# UNITED STATES PATENT AND TRADEMARK OFFICE

APPLICATION NO.	FILING DATE	FIRST NAMED INVENTOR	ATTORNEY DOCKET NO.	CONFIRMATION NO.
10/646,097	08/22/2003	Hugh M. Herr	OSSUR.010C1	8407

Office Action Summary

## **DETAILED ACTION**

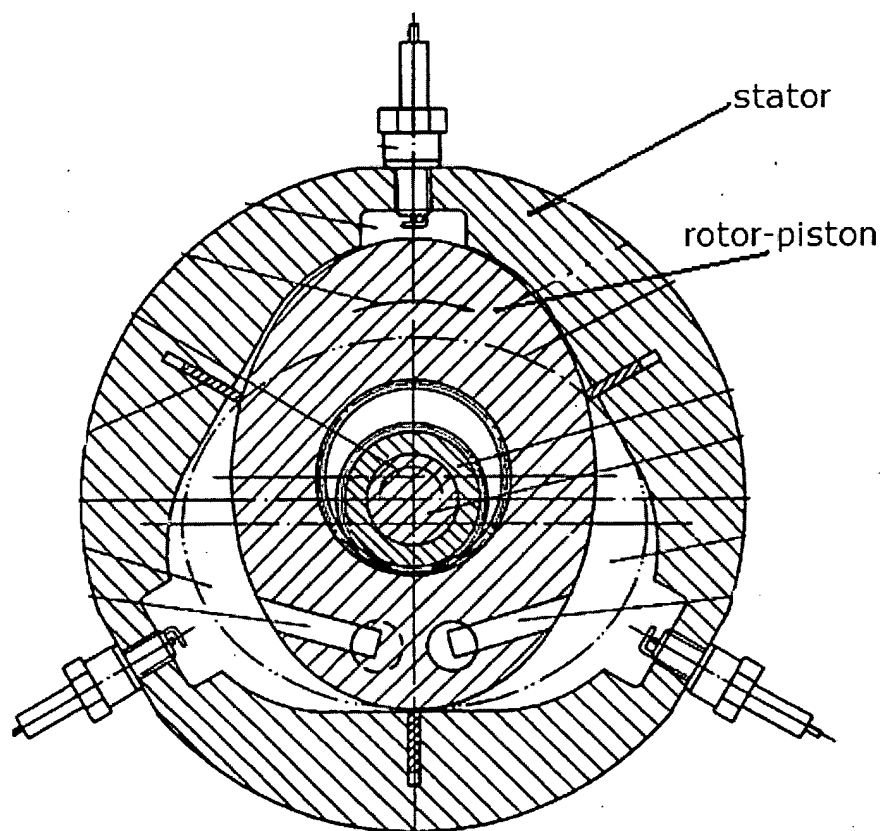
Referring to Figure 1, Biedermann discloses a prosthetic knee system, and the method of controlling it (see column 2, lines 43-65), comprising a rotary magneto-rheological damper/brake operating primarily in shear mode (see column 1, line 67 to column 2, line 14; column 3, lines 1-7), a knee angle sensor (see column 2, lines 15-17), a load sensor (see column 2, lines 24-32; strain gauges are well-known load sensors), and a control unit 10 comprising a CPU and a data memory (see column 2, lines 33-42). At least one knee movement characteristic is measured, identified as a "control state", which "control state" is used to calculate a damping value, which damping value is used to control the resistance of the rotary magneto-rheological damper/brake operating in shear mode (see entire document). Biedermann, as an option, disclose a rotary piston "provided with vanes having a defined resistance within the cylinder dependent on the viscosity of the magneto-rheological liquid" (see column 3, lines 1-7), which rotary piston provided with vanes will subject the magneto-rheological liquid to shearing strain/stress.

Regarding apparatus/device claim 65, the functional limitations "operating primarily in shear mode"; "configured to measure"; "configured to send", etc., carry no patentable weight in the absence of any distinguishing structure. Claims directed to apparatus must be distinguished from the prior art in terms of structure rather than function. *In re Danly*, 263 F.2d 844, 847, 120 USPQ 528, 531 (CCPA1959). "[A]pparatus claims cover what a device is, not what a device does." *Hewlett-Packard Co. v. Bausch & Lomb Inc.*, 909 F.2d 1464, 1469, 15 USPQ2d 1525, 1528 (Fed. Cir. 1990). Expressions relating the apparatus to contents thereof during an intended operation are of no significance in determining patentability of the apparatus claim. *Ex parte Thibault*, 164 USPQ 666, 667 (Bd. App. 1969).
